London Luton Airport Expansion

**8.118 Applicant's Response to Issue Specific Hearing 4 Action 7 –
Update on Road Safety Audits**

Report title:	Stage 1 Road Safety Audit Designer's Response-M1 Junction 10
Date:	November 2023
Document Reference and Revision:	TR020001/APP/8.118
Prepared by:	Neil Scott
On behalf of:	Luton Rising

Figure 3.1: Swept Paths - Eaton Green Road / Lalleford Road

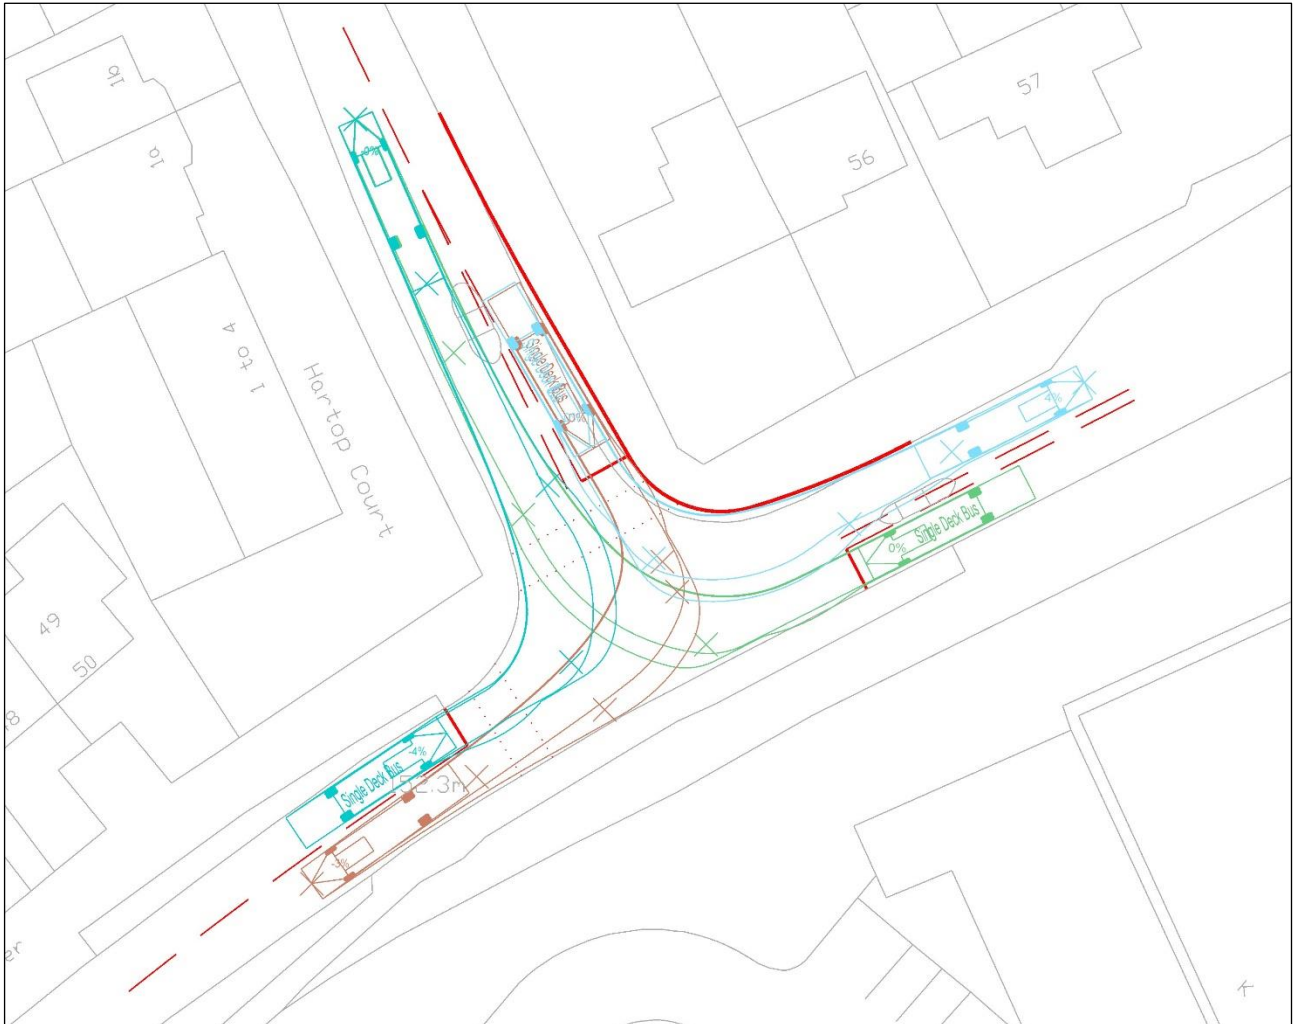
Ref.	RSA Problem	RSA Recommendation	Design Organisation Response	Overseeing Organisation Response	Agreed RSA Action
	Road is a bus route). As a result, large vehicles may mount the kerbs or strike street furniture, creating a hazard to other road users or pedestrians walking along the footway.	position of the stop lines adjusted if required.	to ensure that all manoeuvres can be accommodated without overrunning stop lines – see Figure 3.1.	checked at subsequent design stages.	at subsequent design stages.

3.2.1 Figure 3.1 above shows the swept path analysis for 12m single deck buses at the proposed signalised junction between Eaton Green Road and Lalleford Road.

Figure 3.1: Potential Pedestrian Crossing Improvements

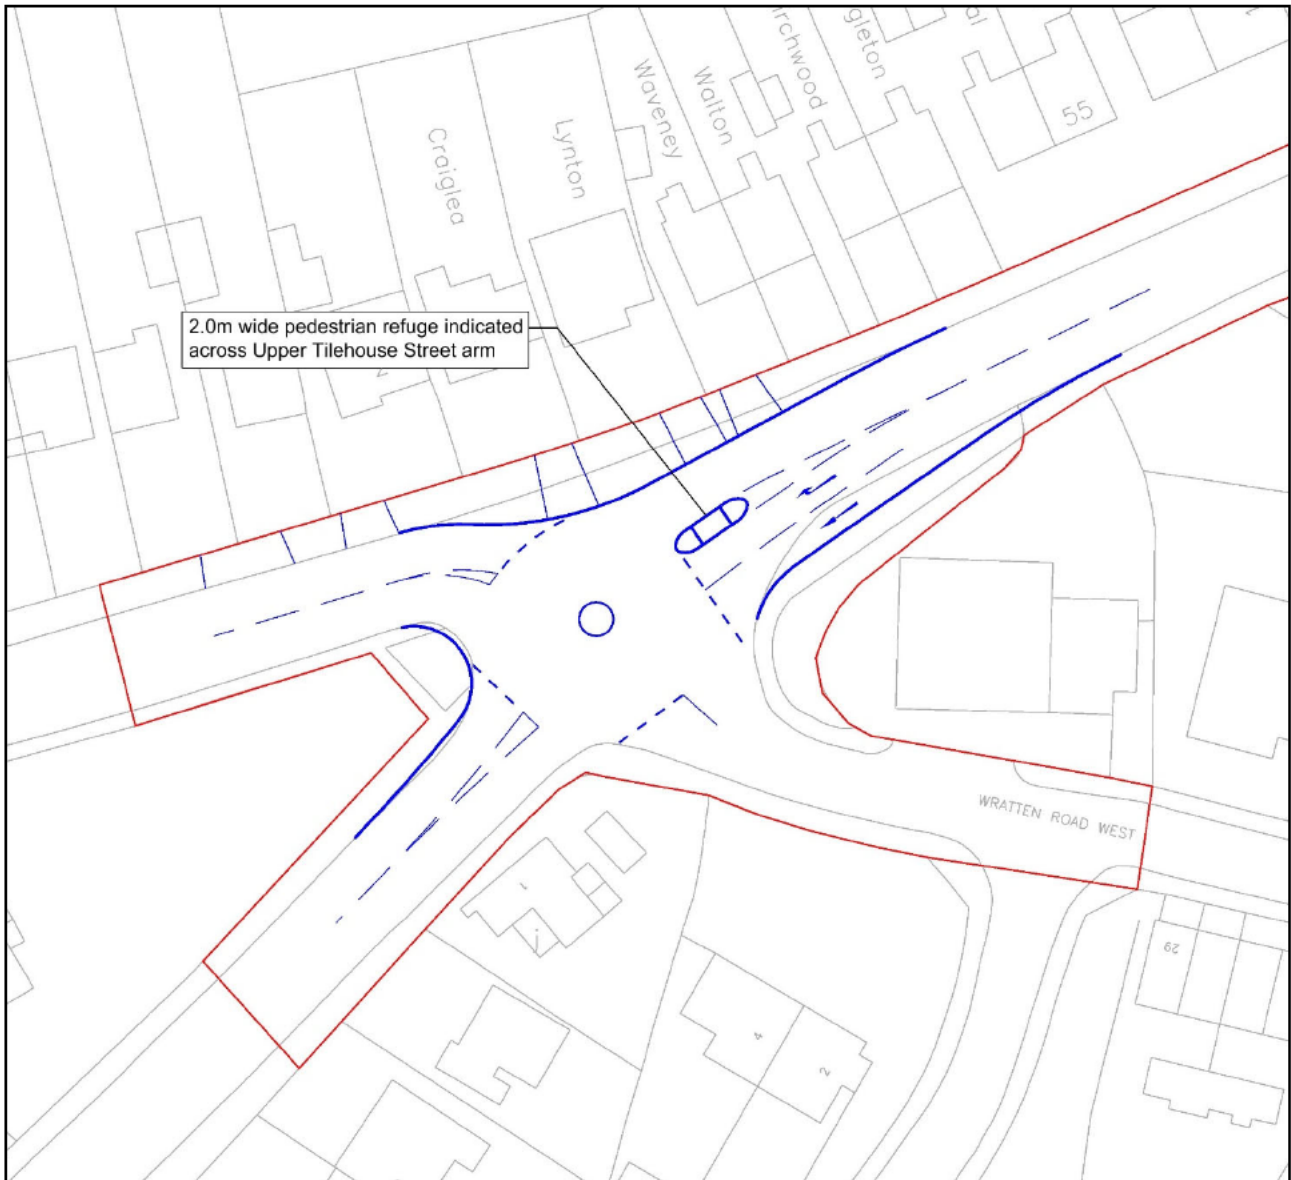
3.2	The widening to two lanes could make crossing movements more hazardous for pedestrians, especially at peak-times when traffic flows are likely to be high. This could increase the risk of pedestrians being struck by vehicles.	An uncontrolled pedestrian crossing point should be provided, with a wider physical central island specified.	Accepted. An uncontrolled crossing on Upper Tilehouse Street has been incorporated into the proposed layout as shown on Figure 3.1.	Disagree: At detailed design stage it is too late to address this issue. Pedestrian crossing facilities must be addressed at this stage in line with HCC policy.

3.2.1 Figure 3.1, below, shows an indicative arrangement to provide a pedestrian crossing on the eastern arm of the mini-roundabout.

3.2.2 Figure 3.1 shows an indicative revised junction arrangement which incorporates a pedestrian refuge across Upper Tilehouse Street. Existing residential dropped kerb accesses are also highlighted along the northern side of Upper Tilehouse Street and Pirton Road, in the vicinity of the junction.

Figure 3.1: Existing Tree Locations – A602 Park Way

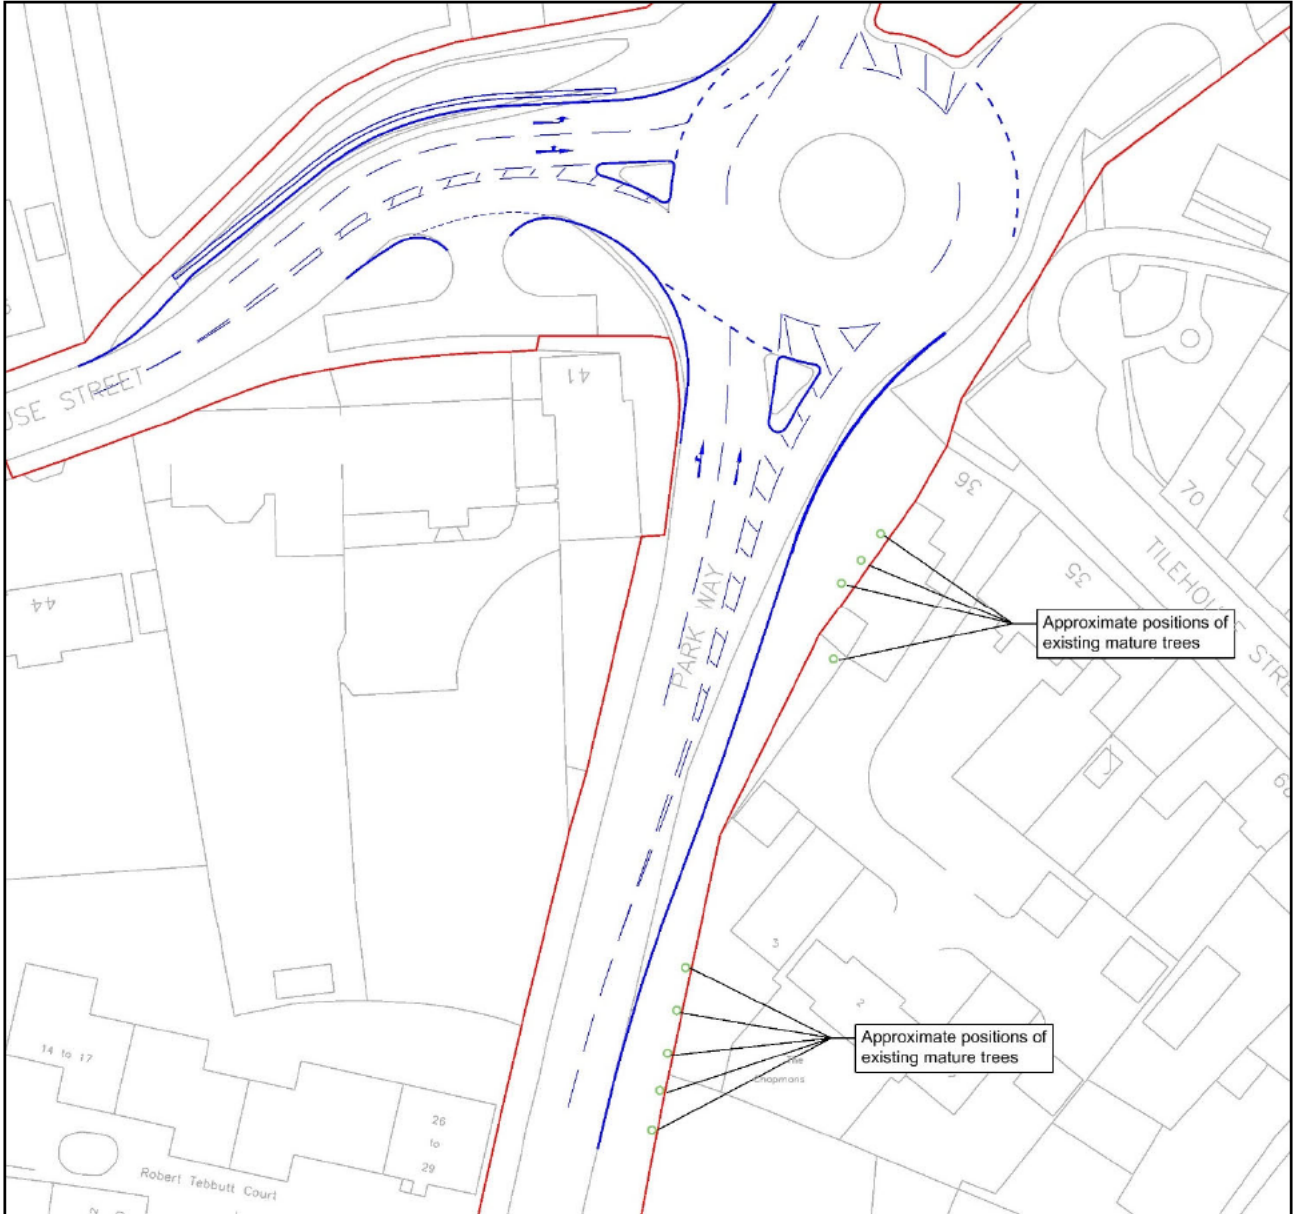
3.2	There are mature trees, dense vegetation, signs and lamp columns on the eastern side of Park Way, that could be impacted by the carriageway widening works. If these items are positioned close to the edge of carriageway, there could be an increased risk of them being struck by errant vehicles, resulting in injury to road users.	It should be ensured that any dense vegetation and mature trees are removed if they are likely to be positioned close to the edge of carriageway and other items of street furniture relocated as necessary.	Accepted. Figure 3.1 shows the indicative locations of mature trees in the area where road widening is proposed. The mature trees are within the Hitchin Conservation Area but do not have Tree Preservation Orders. They are generally located close to the highway boundary and would not be close to the widened road carriageway edge. It is not therefore expected	Disagree: Mature trees are unlikely to be removed to make way for these works. Further scheme detail will be required to show which trees are affected: This may change the nature of the scheme, easily leading to it being undeliverable. In short, the designer organisation response is not feasible/practical solution.

3.2.1 Figure 3.1, below, shows the existing tree locations along the eastern side of A602 Park Way, together with the proposed Order Limit.

Figure 3.1: Existing Tree Locations

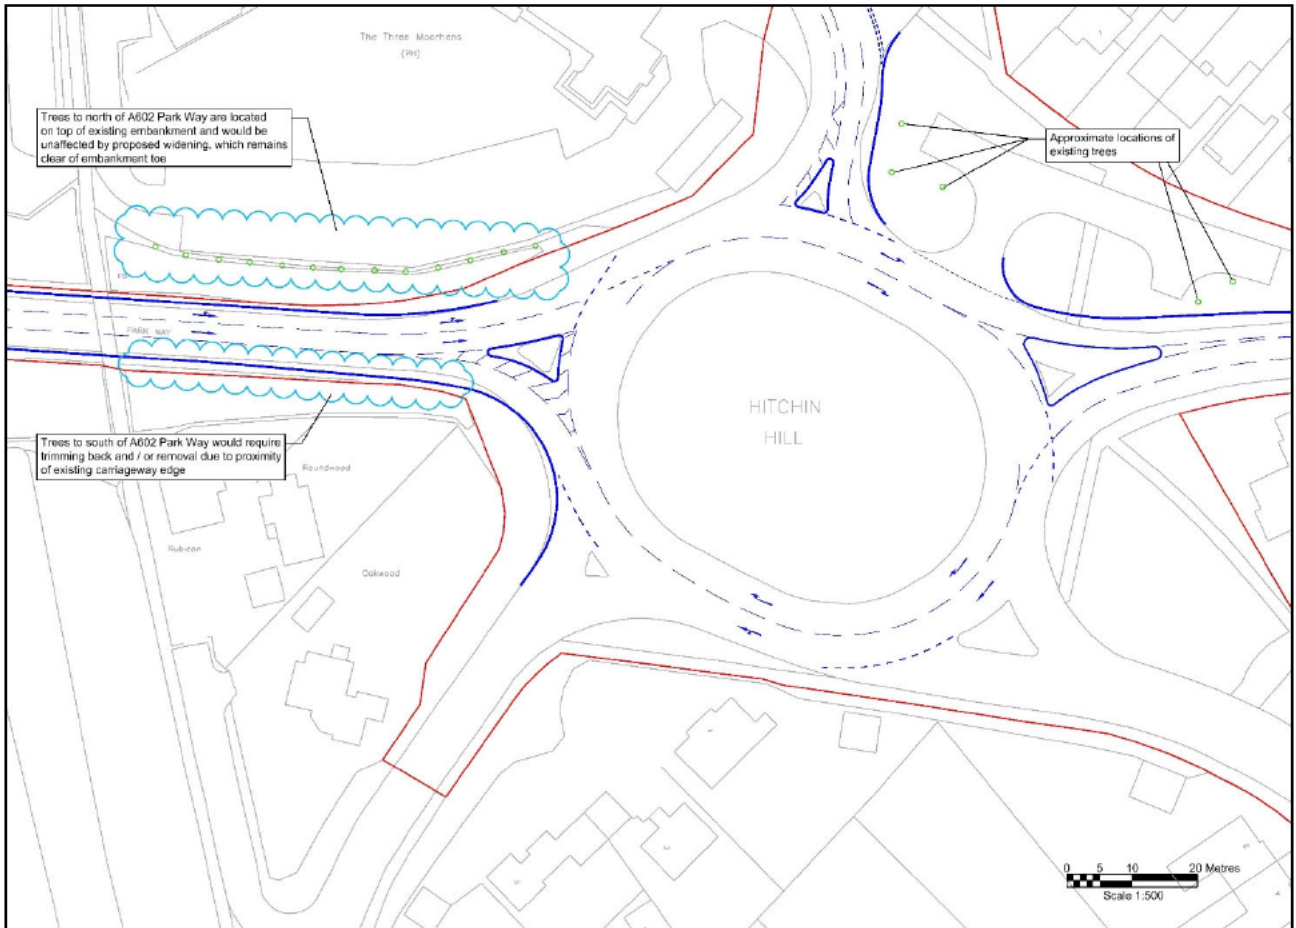
3.2	There are mature trees, dense vegetation, signs and lamp columns on Park Way, that could be impacted by the carriageway widening works. If these items are positioned close to the edge of carriageway, there could be an increased risk of them being struck by errant vehicles, resulting in injury to road users.	It should be ensured that any dense vegetation and mature trees are removed if they are likely to be positioned close to the edge of carriageway and other items of street furniture relocated as necessary.	Accepted. Figure 3.1 shows the indicative locations of mature trees in the area where road widening is proposed. The trees are not within the Hitchin Conservation Area (HCA) and do not have Tree Preservation Orders. The trees on the north side of A602 Park Way are on an embankment and are set back from the road carriageway edge where it is not therefore expected that the trees would need removing. On the south side, it is likely that some trees	Disagree: Mature trees are unlikely to be removed to make way for these works. Further scheme detail will be required to show which trees are affected: This may change the nature of the scheme, easily leading to it being undeliverable. In short, the designer organisation response is not feasible/practical.

3.3	<p>There are numerous heavy-duty items of street furniture, such as lamp columns, utility cabinets and a telegraph pole, in addition to mature trees, that will be impacted by the carriageway widening works. If these items are positioned close to the edge of carriageway, there could be an increased risk of them being struck by errant vehicles, resulting in injury to road users.</p>	<p>It should be ensured that street furniture is relocated, and mature trees removed as necessary as part of the widening works.</p>	<p>Accepted. Figure 3.1 shows the indicative locations of mature trees in the area where road widening is proposed. The trees are not within the Hitchin Conservation Area (HCA) and do not have Tree Preservation Orders.</p> <p>Nevertheless, there is flexibility in the design of the Hitchin Hill approach to move the kerblines away from the closest trees by reducing the lane widths and/or the central hatched area – this is shown on Figure 3.1.</p> <p>The mature trees on the north side of the A602 westbound approach are</p>	<p>Disagree: Mature trees are unlikely to be removed to make way for these works. Further scheme detail will be required to show which trees are affected: This may change the nature of the scheme, easily leading to it being undeliverable. In short, the designer organisation response is not feasible/practical.</p>

3.2.1 Figure 3.1, below, shows the approximate locations of existing trees in the vicinity of the A602 Park Way / Hitchin Hill arms of the junction, together with a potential minor amendment to the Hitchin Hill arm of the junction to minimise potential impact on trees to the east.

Figure 3.1: Swept Paths – B653 Gipsy Lane / A1081 New Airport Way Link Road

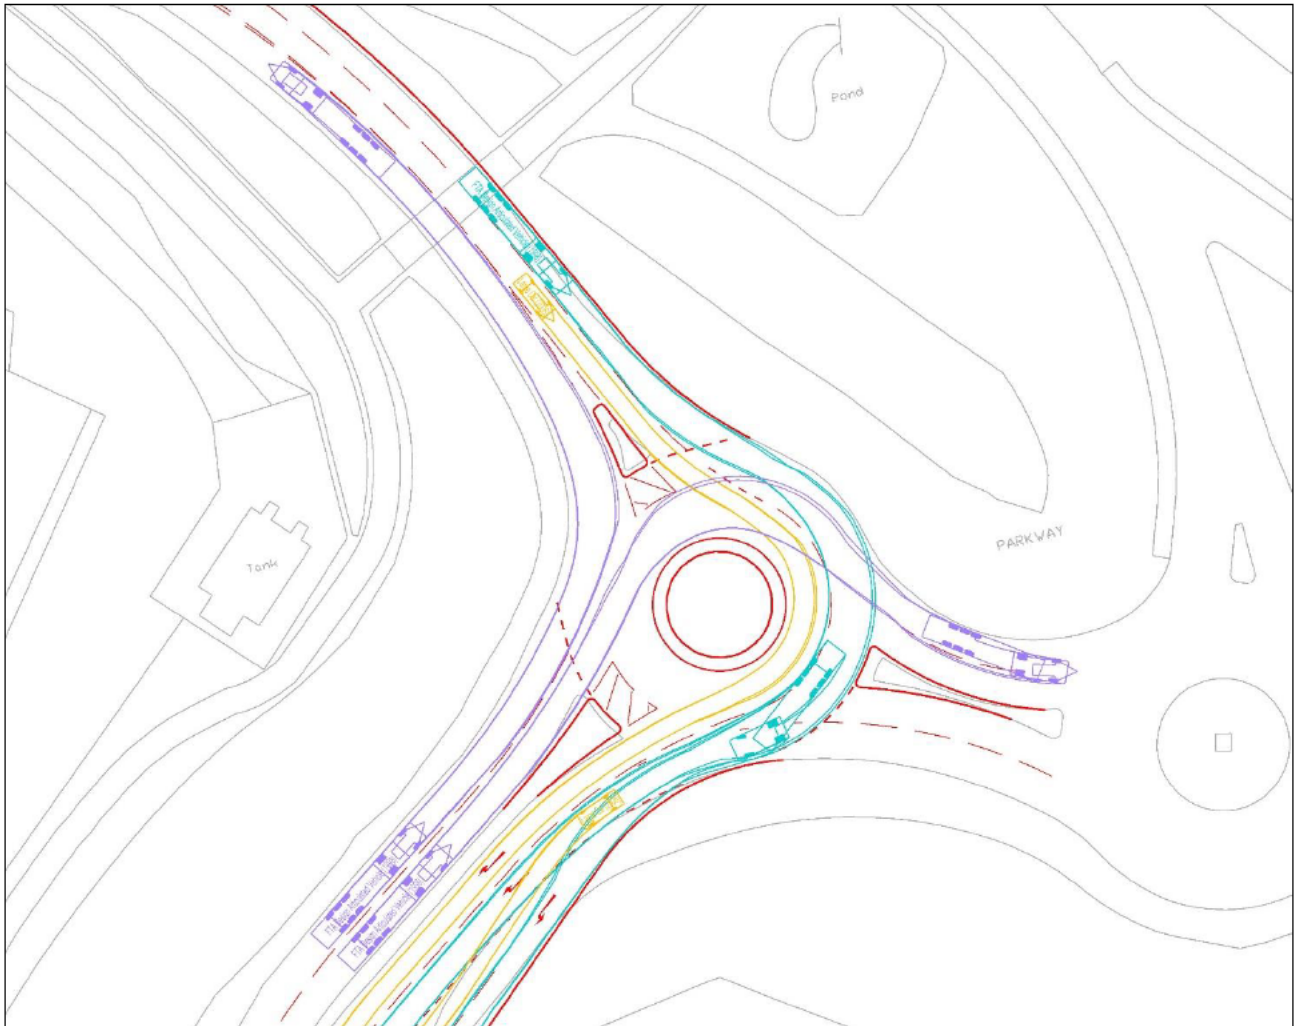
Ref.	RSA Problem	RSA Recommendation	Design Organisation Response	Overseeing Organisation Response	Agreed RSA Action
			<p>lane of the A1081 without entering the middle lane.</p> <p>Whilst the HGV path crosses two of the three proposed lanes on the A1081, there are only two left turn lanes entering the A1081, which means a parallel left turning car would still be able to enter the offside lane of the A1081. To guide vehicles, white lining would be provided as shown on Figure 3.2.</p> <p>If concerns over a left turning HGV remain, the widening of the left turn to create two approach lanes could be removed from the proposed scheme as it would not have a material impact on the overall operation of the junction. This would mean that the left turn would remain as existing.</p>	<p>appropriate corner radii and associated tapers, to allow for the turning of Heavy Goods Vehicles.</p> <p>As such the swept path analysis demonstrates the need for further revisions to the layout as per the Safety Audit recommendations, in order for a HGV to turn left without straddling lanes, which would appear to require the provision of a corner taper. It is unclear if this can be achieved within the DCO limits or the extent of available public highway.</p>

3.2.1 Figure 3.1 above shows the swept path analysis for 16.5m articulated HGVs and large cars at the roundabout junction between B653 Gipsy Lane and the A1081 New Airport Way link road.
